Re Final Report on Birch Spring Investigation, CO-OP Mining Co., Bear Canyon Mine,
ACT/015/025, Outgoing File

RE: Birch Spring Findings for Technical Directive 005, Co-Op Mining Corporation, Bear Canyon Mine ACT/015/025, and Star Point Mine, ACT/007/006, Internal File

The Issue: The Reason for Decreased Flow at Birch Spring is Undetermined.

Figure 1.

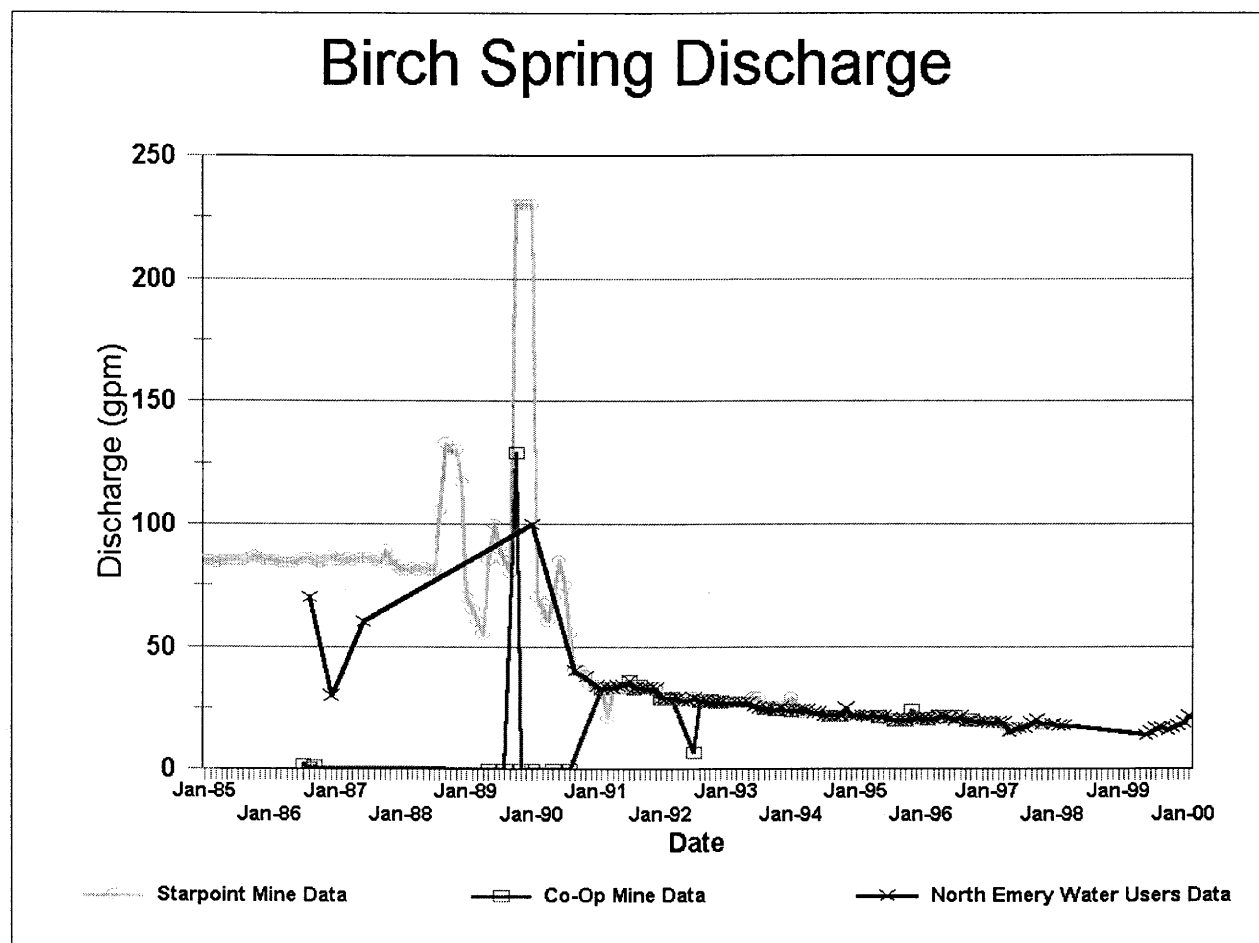
- Figure 1 presents current and past discharge data reported in the Star Point Mine, permit no. ACT/007/006; the Bear Canyon Mine, permit no. ACT/015/025; and the North Emery Water Users Association (NEWUA). The raw data are tabulated in Appendix A.

- Based on NEWUA records, flow at Birch Spring declined from 33 gpm in February 1990 to about 19 gpm in 1997, with a 16 gpm low flow recorded May 1997, Figure 1. This decline in flow could result from the drought beginning in 1987 through early 1993. Flows continued to decline to a low of 14 gpm recorded on June 1, 1999. Flows appear to be recovering from this low and the last recorded spring discharge rate provided from NEWUA was 23 gpm on February 18, 2000.

- Data in the Star Point Mine Plan suggest a larger decrease in flow occurred at Birch Spring following the observed peak flows in 1988 through 1991. These peak flows occurred during the same period when flow from the Tie Fork Well increased, which was attributed to an earthquake occurring on August 14, 1988. The first noted change in Birch Spring water characteristics, complaints from the water users that their water had increased sediment, was documented in a memo to the Division dated October 17, 1989. Other anomalies in Birch Spring data are noted in a memo from Jeffery W. Appel to Mr. Kingston. This memo identified "odd fluxuations in the water quantities" and questioned an "unsatisfactory water sample of Birch Spring on August 1, 1991."

Birch Spring Investigation: Spring Source #1

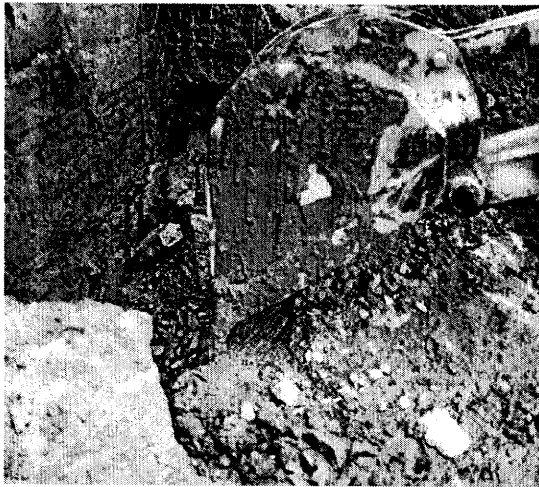
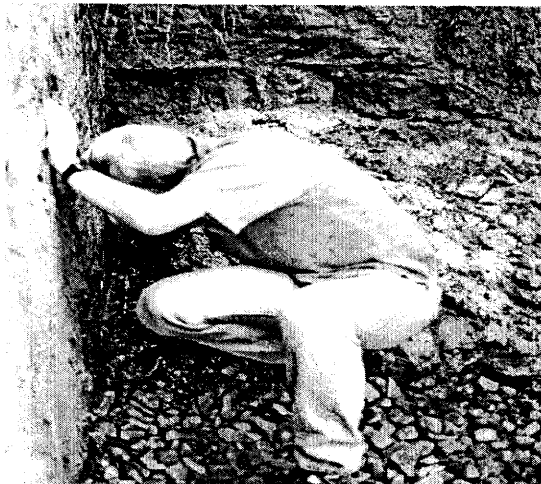
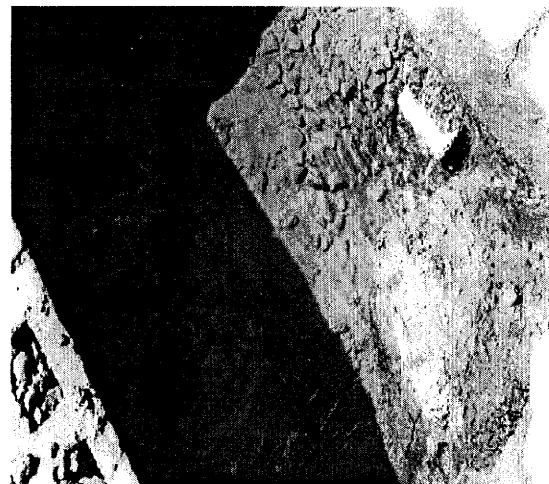
Spring Source #1, as shown on Map 1, is located on the west side of the alcove and is the down gradient source (Figures 1-4). Water was running over the collection box in (Figure 2) prior to opening the box. Silt and sediments were noted in the fracture and collection box when it was unearthed (Figures 3 and 4). Charles Reynolds is removing silt from the fracture in Figure 3.

Birch Spring Investigation: Spring Source #2

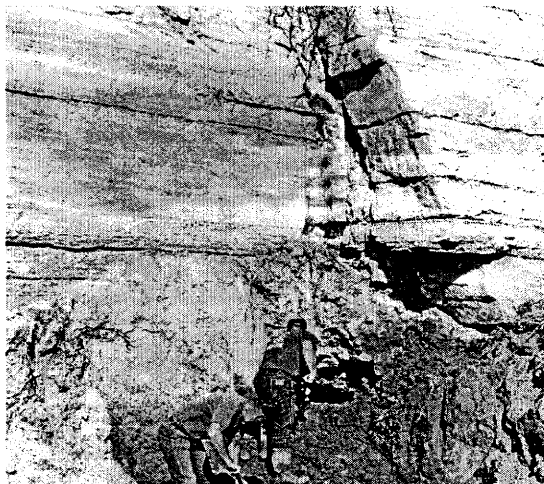
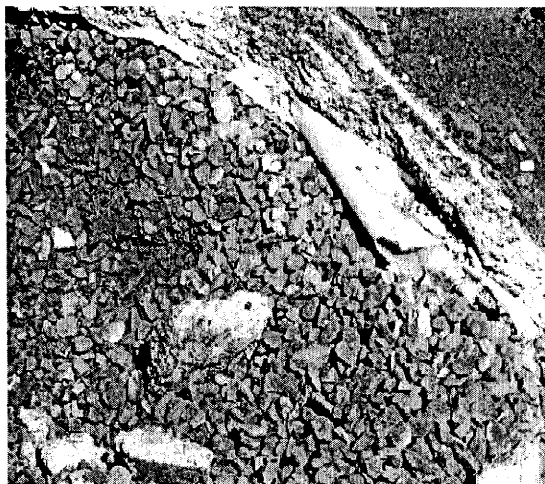
Spring Source #2 is located on the west side of the alcove and is the up gradient source #2 as shown in Map 1. Silt and sediments were noted in the gravel filter.
